## ADDENDUM NO. 6

DATE: January 25, 2016

Contract 15-C-00022; Hanna Pumping Station Replacement

Item 1: Replace plan sheet nos. 2, 3, E3, E4, E5, E7, E8 and E9 with the attached plan sheet nos. 2, 3, E3, E4, E5, E7, E8 and E9.

**HANNA PUMPING STATION**  
VALVE REPLACEMENT  
ELECTRICAL DETAILS

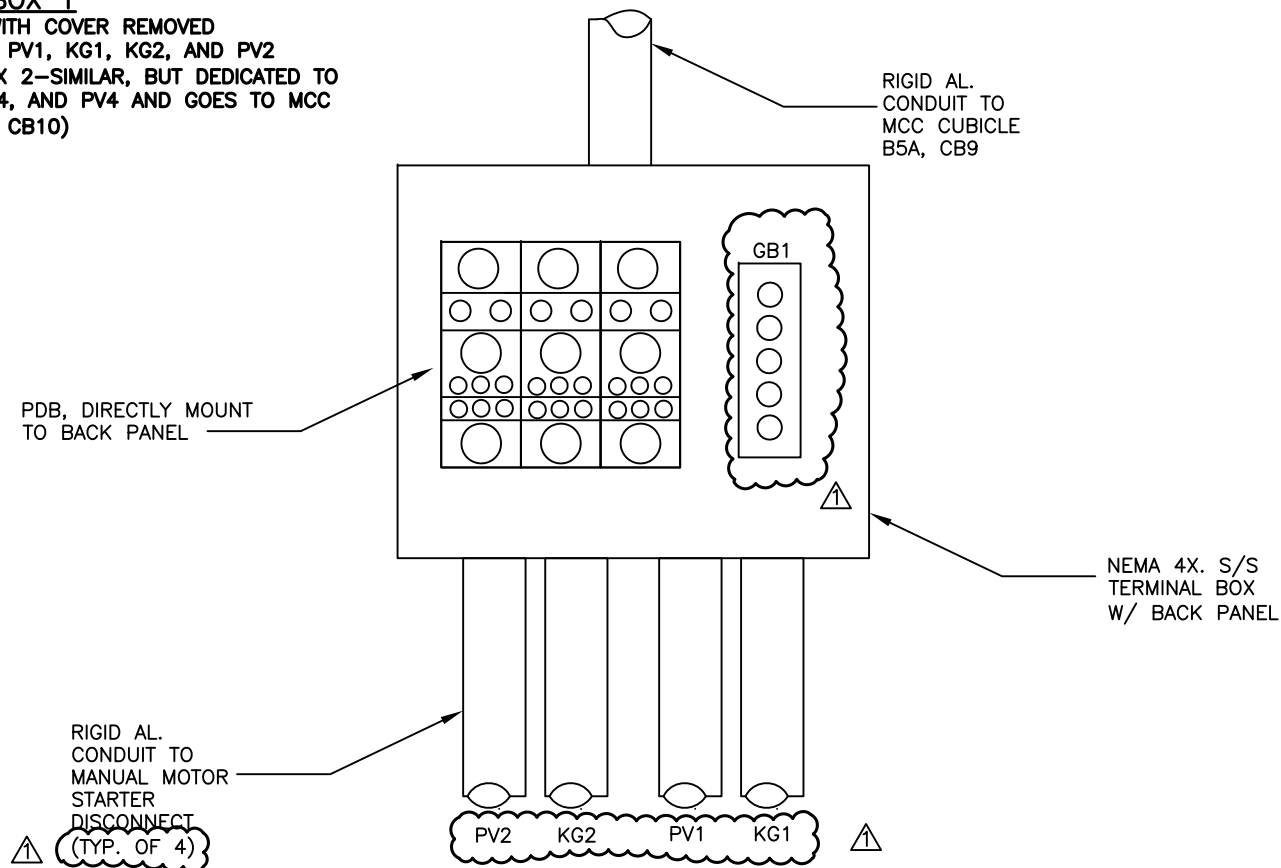
- ⑧ PROPOSED 3/4" CONDUIT, (3)#12 AWG. & (1)#12 GND. FROM PROPOSED TERMINAL BOX 2 TO PROPOSED MOTOR STARTER DISCONNECT (TYP. OF 4)
- ~~⑨ PROPOSED 3/4" CONDUIT, (3)#12 AWG. & (1)#12 GND. (FROM PROPOSED MOTOR STARTER DISCONNECTS PV3 TO PROPOSED TERMINAL BOX 2)~~

- ~~⑩ PROPOSED 3/4" CONDUIT, (3)#12 AWG. & (1)#12 GND. (FROM PROPOSED MOTOR STARTER DISCONNECTS PV4 TO PROPOSED TERMINAL BOX 2)~~
- ⑪ PROPOSED NEMA 4 MANUAL MOTOR STARTER DISCONNECTS, TYPICAL OF 8
